# SUBDIVISION REPORT - CONCEPT/DEVELOPMENT PLAN

► **FILE #:** 6-SB-25-C

► **SUBDIVISION:** THE HAVEN AT HARDIN VALLEY

► **PROPOSED USE:** Adding 13 additional lots to an approved single family residential neighborhood (1-SA-22-C/1-D-22-UR)

CONCEPT & USE OF REVIEW PLAN  
 HAVEN @ HARDIN VALLEY PHASE 3  
 TAX MAP 117, PART OF PARCEL 8.12  
 DISTRICT #6, KNOX COUNTY, TENNESSEE

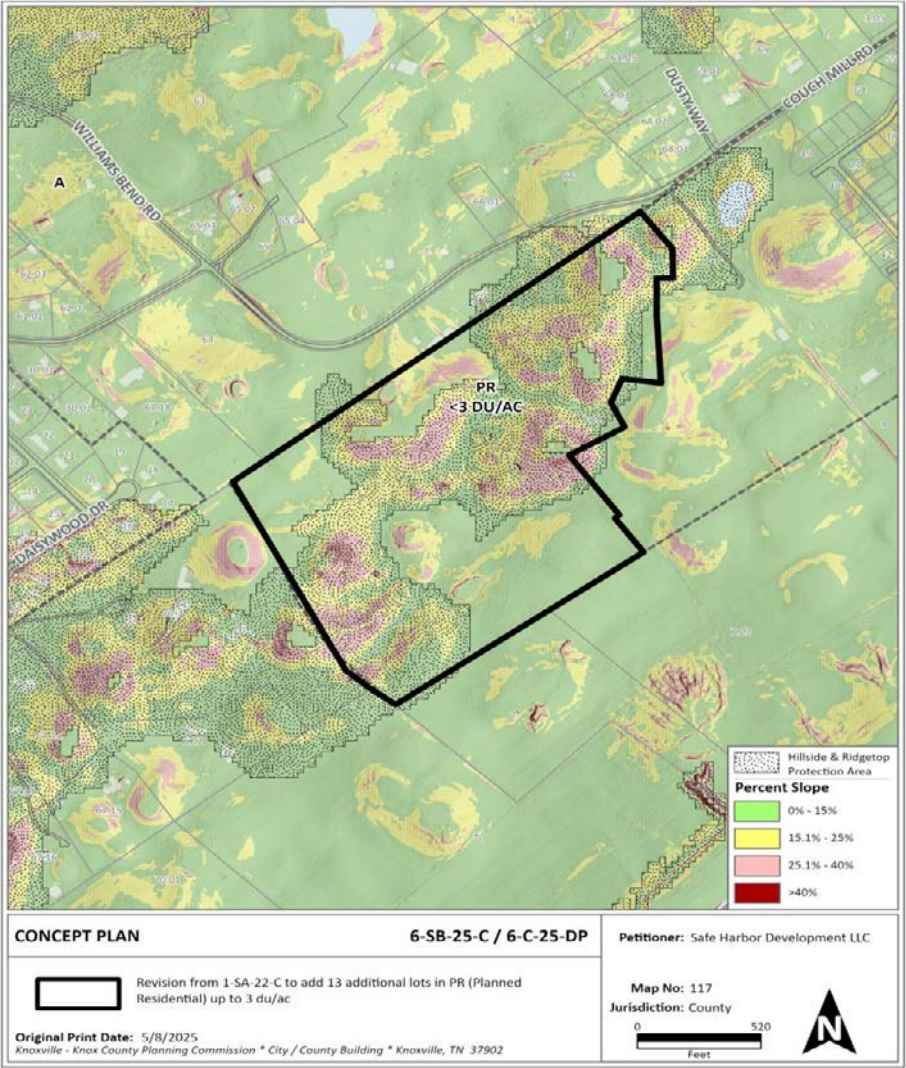
► **SUBDIVISION VARIANCES REQUIRED:** **VARIANCE**  
1. Allow a T-turnaround in lieu of a cul-de-sac at the western terminus of Signal View Road.

The applicant requests a T-turnaround instead of a cul-de-sac at the western terminus of Signal View Road. This is intended to be temporary because this is a stub street that will provide future access to the adjacent property to the west. Staff recommend approval of this request because of the short length of this street segment (approximately 308 ft) and the limited number of houses (7). The proposed T-turnaround must meet AASHTO design standards.

There are approximately 31.82 acres of hillside protection (HP) area in the 50.65 acres in the slope analysis. This acreage is approximately 5 acres more than stated on the concept plan for Phase 3 due to the difficulty in matching the case boundary to a development boundary that does not align with parcel lines and has several changes in direction. The slope analysis recommends a disturbance budget of 18.76 acres of the 31.82 acres in the HP area.

slope analysis, created in conjunction with the review of the 2022 concept plan, states that there are 37.48 acres in the HP area and recommends a disturbance budget of 23 acres in the HP area. Most of the HP area is located around the large sinkholes in the northwest portion of the property, which are predominantly in Phase 3. Besides the steep slopes associated with the sinkholes, the property consists mainly of rolling hills. The 2022 concept plan disturbed approximately 20.9 acres of the HP area, which complies with the slope analysis recommendations. The road layout and location of lots have remained relatively unchanged, resulting in no significant change in the disturbance area.

- **Approve the variance to allow a T-turnaround in lieu of a cul-de-sac at the western terminus of Signal View Road.**
- A. The T-turnaround on this stub street will allow for future access to the adjacent properties and allow for less grading into an area with steep slopes and a closed contour (possible sinkhole).
  - B. The road stub-out was a requirement of the 2022 concept plan approval, and the T-turnaround will allow for the conversion to a standard road cross section when the road is extended into the adjacent property.
  - C. The granting of the variance will not be detrimental to public safety, health, or welfare because the turnaround meets the American Association of State Highway and Transportation Officials (AASHTO) standards.

10. Providing the proposed road stub-out at the western terminus of Signal View Road and notification of future street connections per Section 3.04.C.2.b. & d. of the Subdivision Regulations.

11. The temporary turnaround at the western terminus of Signal View Road must meet the American Association of State Highway and Transportation Officials (AASHTO) design standards, as required during the

design plan phase by Knox County Engineering and Public Works. The portions of the turnaround located outside of the 50-ft public right-of-way may be put in an easement.
